Docket Number:	18-IRP-01
Project Title:	Integrated Resource Plan
TN #:	225732
Document Title:	Final Staff Report - Review of Anaheim Public Utilities 2018 Integrated Resource Plan
Description:	N/A
Filer:	Harinder Kaur
Organization:	California Energy Commission
Submitter Role:	Commission Staff
Submission Date:	11/1/2018 8:42:06 AM
Docketed Date:	11/1/2018

FINAL STAFF REPORT

Review of Anaheim Public Utilities 2018 Integrated Resource Plan

Figure 1: Anaheim and Energy Commission Energy Forecasts 2018-2030 (GWh)

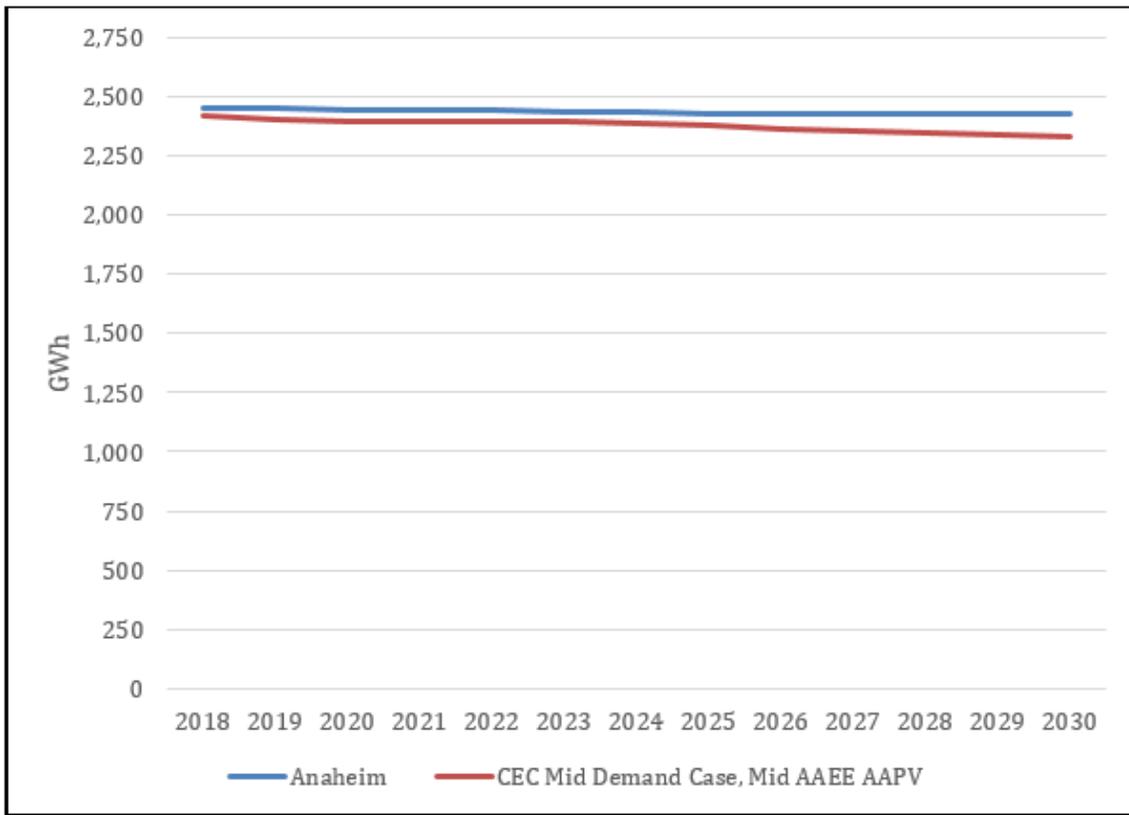
The Energy Commission’s most recent forecast for Anaheim (*California Energy Demand 2018 – 2030 Revised Forecast*) is close to Anaheim’s forecast, with a difference of 1.2 percent in 2018, increasing to 4.1 percent by 2030. The Energy Commission forecasts energy demand of 2,422 GWh in 2018 declining to 2,333 GWh in 2030, with average annual growth of -0.31 percent under the mid demand baseline case, with mid additional achievable energy efficiency (AAEE) and additional achievable PV (AAPV) savings, as shown in Figure 1.

The differences between Anaheim’s and the Energy Commission’s forecasted energy demand are likely attributed to Anaheim’s exclusion of economic and demographic factors in their forecasting methodology, which are included in the Energy Commission’s forecast. Anaheim explains that the City of Anaheim is a fully developed city with historically consistent growth in income and employment rates and notes that inclusion of economic and demographic factors lead to increased forecast variability.

However, Energy Commission staff observes that Anaheim’s energy demand experienced a significant decline during the economic recession from 2008 to 2011, showing a correlation to economic conditions.

Figure 2: Anaheim and Energy Commission Peak Forecasts 2018 — 2030 (GWh)

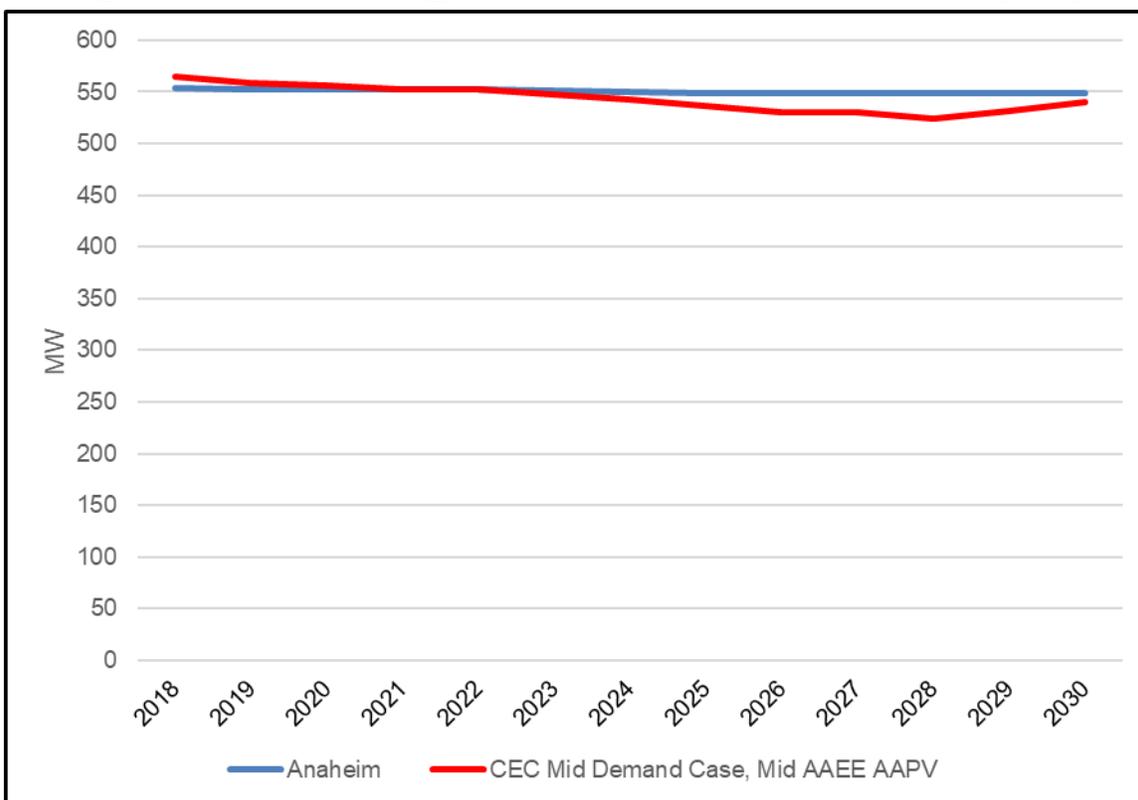
Anaheim’s peak forecast is close to the Energy Commission’s forecast for Anaheim (*California Energy Demand 2018 – 2030 Revised Forecast*), mid demand baseline case, with mid AAEE and AAPV savings, as shown in Figure 2.

Anaheim forecasts a peak demand for utility-provided energy of 553 MW in 2019, with customer solar PV generating 3 MW. In 2030, the forecast for utility-provided energy at peak demand is 549 MW, with an additional 21 MW of power coming from customer solar PV. In 2018, the difference from the Energy Commission’s peak forecast is - 1.9 percent; this increases to 4.8 percent by 2028, and falls to 1.7 percent in 2030. The increasing peak demand in the last two years of the Energy Commission’s forecast represents the shift in the timing of peak system load, which is pushed back an hour by significant amounts of solar PV. This later peak hour diminishes the impact of both efficiency savings and behind-the-meter PV.

Figure 3: Sources of Renewable Portfolio Standard Eligible Energy 2019 — 2030 (MWh)

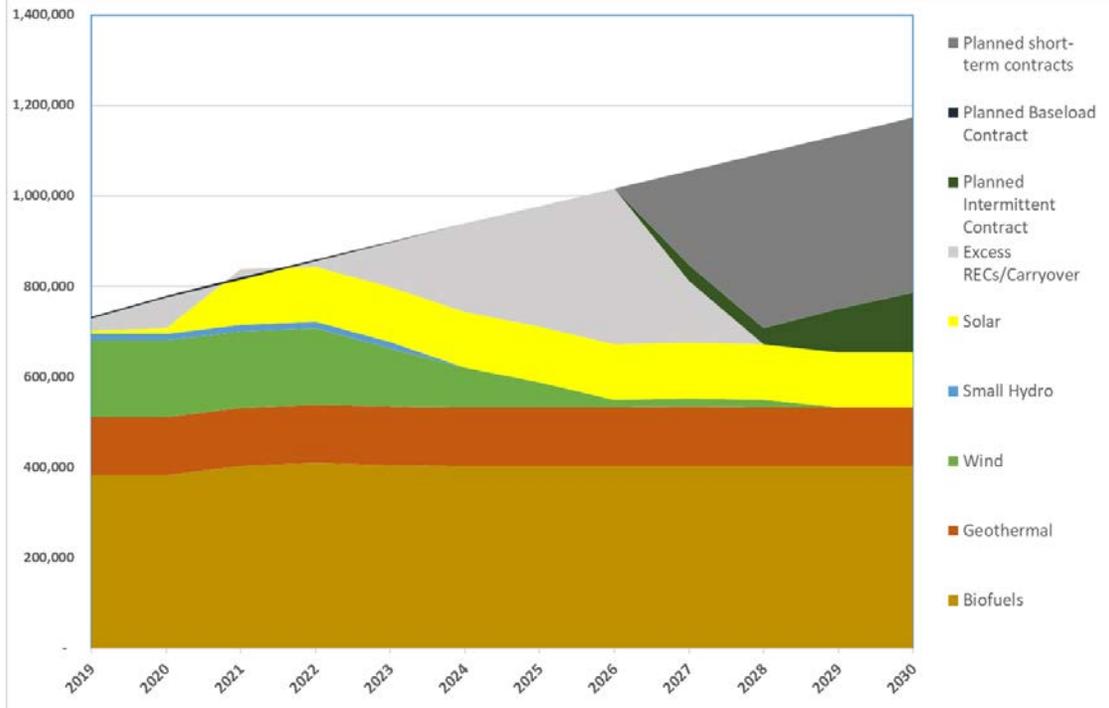
2028, Anaheim will increasingly rely on short-term contracts for renewables beginning in 2027. Anaheim’s Renewable Procurement Table (RPT), part of the standardized tables of the IRP Filing, includes forecasted retail sales and RPS procurement targets.

Anaheim reported in the standardized tables procuring enough RPS eligible resources from either existing contracts or planned baseload and intermittent resources to meet or exceed their targets in Compliance Periods 3-6, including 50 percent renewable by 2030, when combined with excess balances from previous compliance periods.²⁵

Figure 4: Anaheim Renewable Portfolio Standard Renewable Portfolios in 2019 and 2030

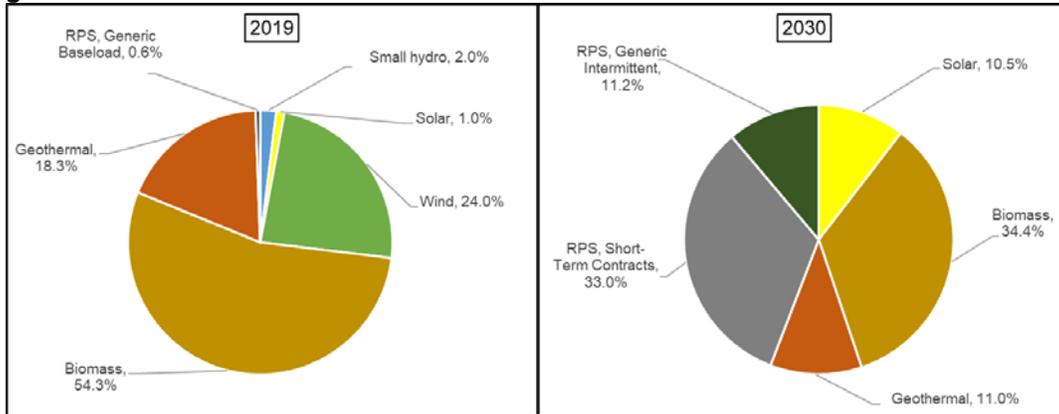
Anaheim expects to meet much of the remainder of their renewable energy needs in 2030 with longer-term contracts with variable-energy resources and short-term contracts. Figure 4 shows the resource mix of Anaheim’s renewable portfolio in 2019 and 2030.

Three existing wind contracts that currently provide 24 percent of Anaheim’s RPS energy needs will expire during 2023 to 2028. During 2023 — 2026, Anaheim plans to rely on their excess balances from previous compliance periods to meet a share of their requirements, with use of these reaching 25 percent of the total procurement requirement in the 2025 to 2027 compliance period. In the compliance period from 2028 to 2030, short-term contracts meet roughly a third of the energy needed to satisfy the RPS.

Figure 5: Anaheim Portfolio Comparison for 2019 and 2030

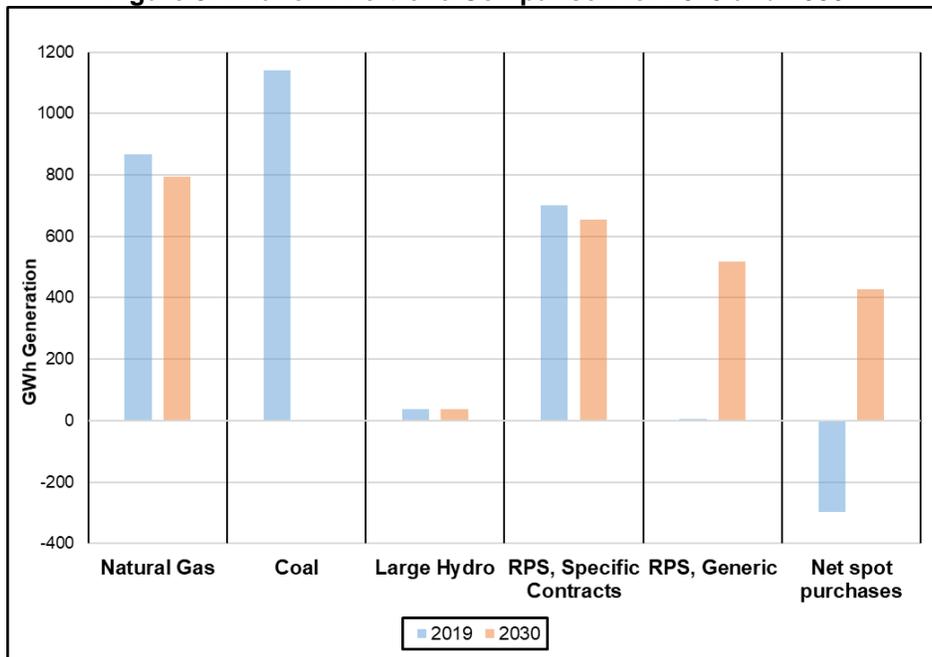
PUC section 9621(d)(1)(D) requires that POU’s address the procurement of a diversified portfolio of resources consisting of both short-term and long-term electricity, electricity related, and demand response products. Based on staff’s review of Anaheim’s existing resources, their portfolio analysis, and the selection of resource additions in their IRP staff concludes that Anaheim has fulfilled this requirement. Figure 5 shows a comparison of the energy mix by resource in Anaheim’s preferred portfolio in 2019 and 2030.

In 2030, Anaheim becomes a net purchaser of energy from the spot market, though they plan to actively purchase and sell energy into the spot market to balance their supply

and demand throughout the planning horizon. This mix of resources eliminates reliance on coal resources and increases the amount of renewable resources and short-term market purchases. As previously discussed, Anaheim concluded that the preferred portfolio has the highest level of diversity, which increases the flexibility, reliability, and performance of generation resources, while also reducing costs.
